8D REPORT

8D-no:	1	**Submit Date:**	18.08.2025
Status:	Open		
Title:	Brush Width side Serration	**Supplier:**	AVO Carbon India.
Part No:	500383-A	**Place:**	Chennai, India.
Reported Date:	09.08.2025		
Editor:	Suresh.A	**Supplier Agent:**	Mr.Ramkumar

Compliant Text: **Brush Width side Serration**

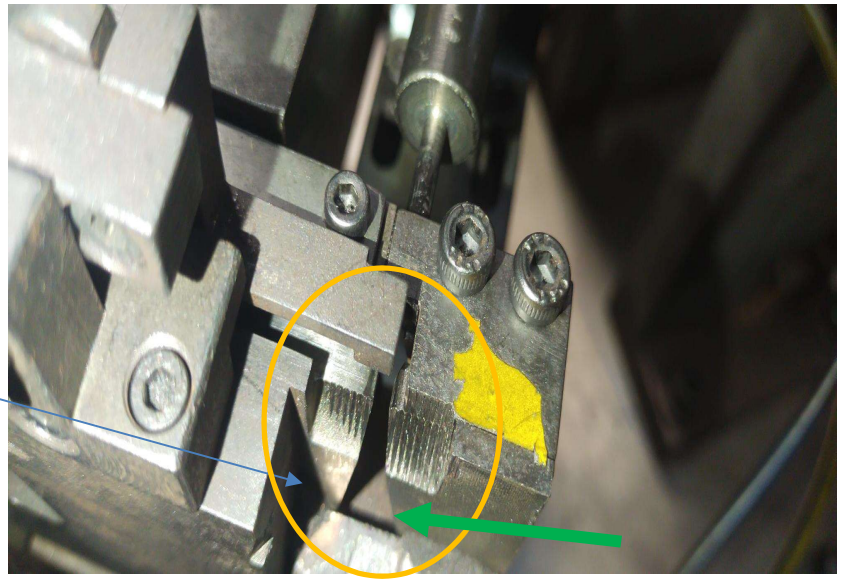
Ejection Gap was less

The fixture gap was less, it leads to brush struck at the station

Brush Ejection fixture was modified, the flexible wire ejection point was cut and gap increased to move parts freely into collection chute, this wide gap was ensure flexible wire not struck with gap
